Planning Inspectorate ref: APP/Y0435/W/20/3252528

Local Planning Authority Ref: 15/00619/FUL

**Proof of Evidence of
James Bedingfeld
On behalf of
Buckinghamshire Council**

13th April 2021

Figure 1: Junction 16 Do Something 1 PM Peak Queue Length VS Network Flow By Arm

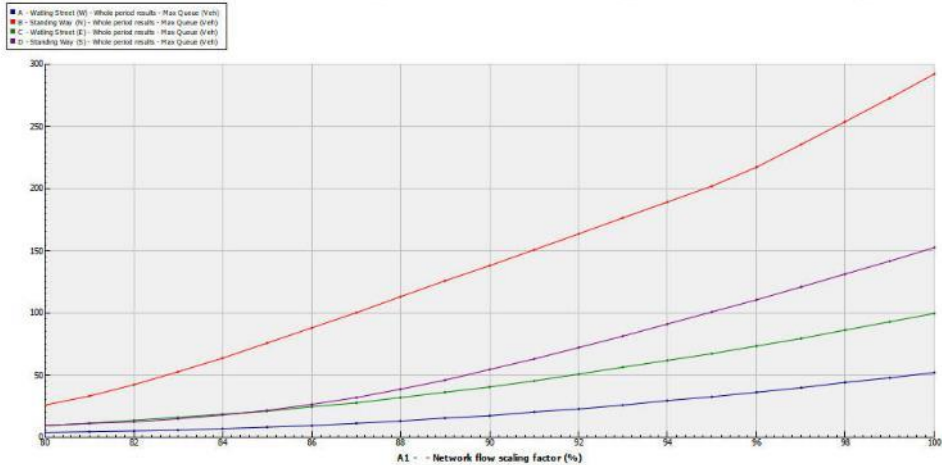
8.106 BC highways registered concern over the potential blocking back to J15 Bleak Hall roundabout. The Appellant provided a response on 7th April 2021 (attached at Appendix H). This highlighted a further review of the junction and the flows used in the model and that only a slight reduction (5%) in network flow would result in no blocking back. It is agreed that a robust growth has been applied to the flows used in the modelling, with TEMPRO growth factor over 15% along with higher banded of employment rates to provide a 'worst case' flow scenario. The Appellant also made reference to the Department for Transport's 'Appraisal and Modelling Strategy – A Route Map For Updating TAG During Uncertain Times' (July 2020) which recommends the use of scenarios to assist with modelling future outcomes. Although the DfT has yet to publish updated forecasts, there is a clear indication of a downward trend in trips to account for the lower economic output.

Output from the analyser is presented in **Figure 1**. This indicates that for the 2033 Do Something 1 PM peak scenario, a small reduction in traffic flow of only 5% would result in the queue being able to be accommodated in the stacking space between Junction 15 and Junction 16.

The results presented in **Figure 1** above demonstrate that a small change in traffic flow (5%) could result in there being no interaction between Junction 15 and Junction 16. As the long term projection for economic growth (and hence trips) is almost certainly on a downward trend based on the DfT's advice, we consider that the risk of interaction between the junctions in 2033 would be minimal.
